Warwick Gmbh & Co Music Equipment KG
 Gewerbepark 46
 D-08258 Markneukirchen
 Tel : +49 (0) 37422 555 - 0
 Fax : +49 (0) 37422 555- 9999
 e-mail : info@warwick.de

SAC PU J5 N ST

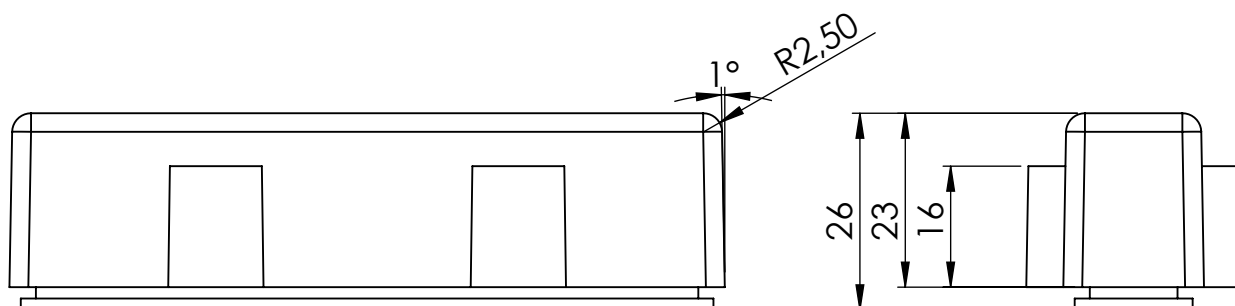
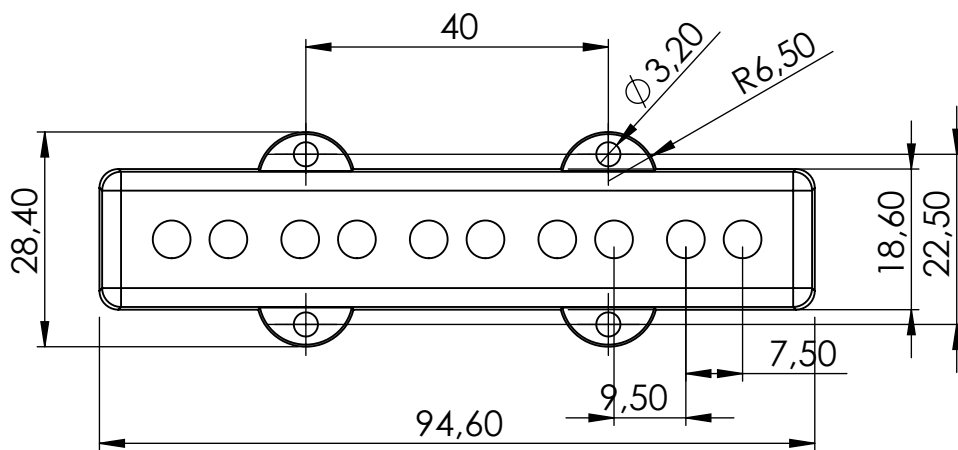
Please add additional 4mm in total height to compensate for the pickup cable!
